CITY OF PORT LAVACA

SUBJECT: CHANGE ORDER FOR CDBG SOUTHSIDE PHASE 2

CDBG-DR
GRANT PROJECT
PHASE 2
PLAN AND PROFILE
NUECES STREET
STA 0+00 TO 4+00

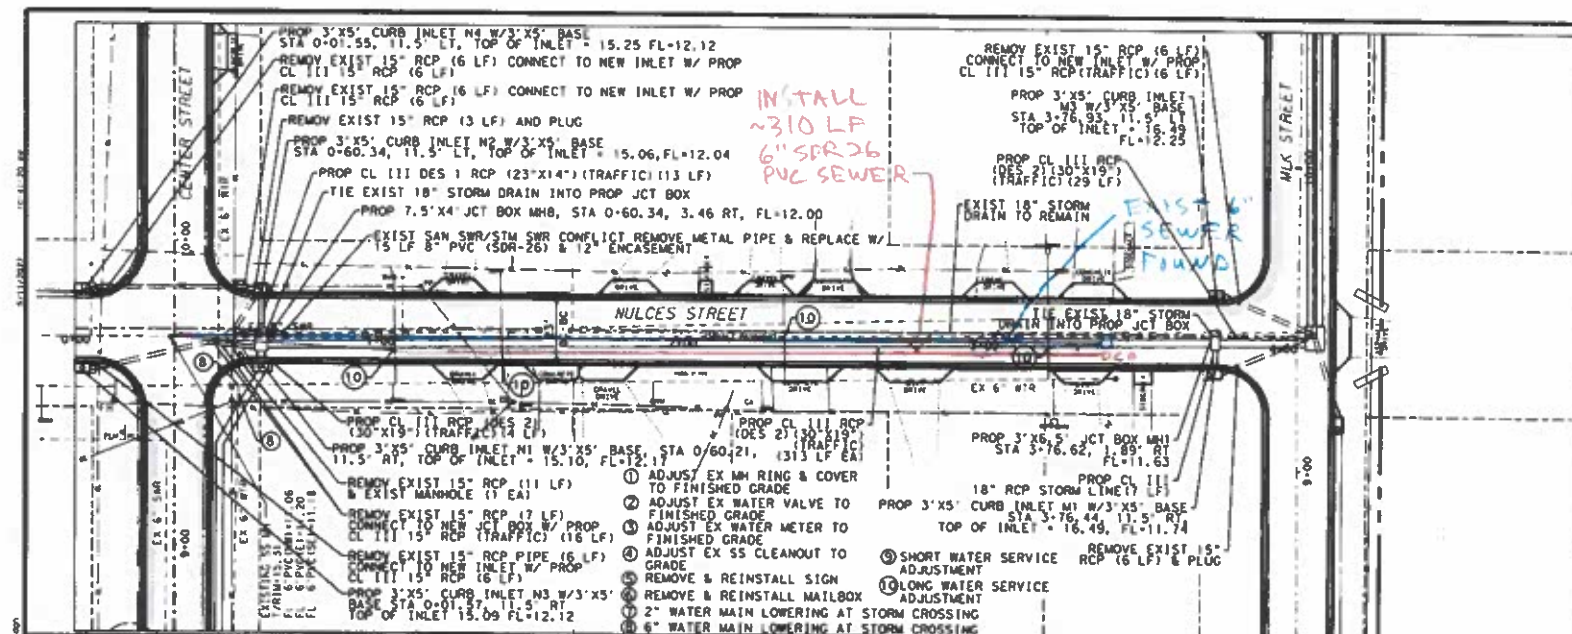
On Nueces St between Center and MLK we originally surveyed a 6" sewer line between a found manhole at Center and a found manhole at roughly Station 3+40. As Lester began working on installing the arch pipe on Nueces up from MLK they discovered an additional 6" sewer line and manhole on the south side of the street. So, there are two 6" sewer lines on either side of the existing 18" storm line in the street down Nueces. We did not know about the other sewer line because the manhole on the upstream side near Sta 3+40 was covered in asphalt and of course we weren't anticipating there being two sewer lines down the same street. It appears that there are two sewer lines due to the sewer line being roughly at the same elevation as the storm sewer line at least for part of the way down Nueces. Since the services couldn't be laid across the storm line, they installed two sewer lines to serve houses on either side of the street. The newly discovered sewer line conflicts with the new arch pipe we are installing down Nueces so that's why we must shift out the sewer line. Statement above is from Randy Janak, PE, CFM with CivilCorp Engineering.

The sewer line needs to be relocated in order to address drainage issues.

Staff recommends awarding the change order in the amount of \$44,700.00.
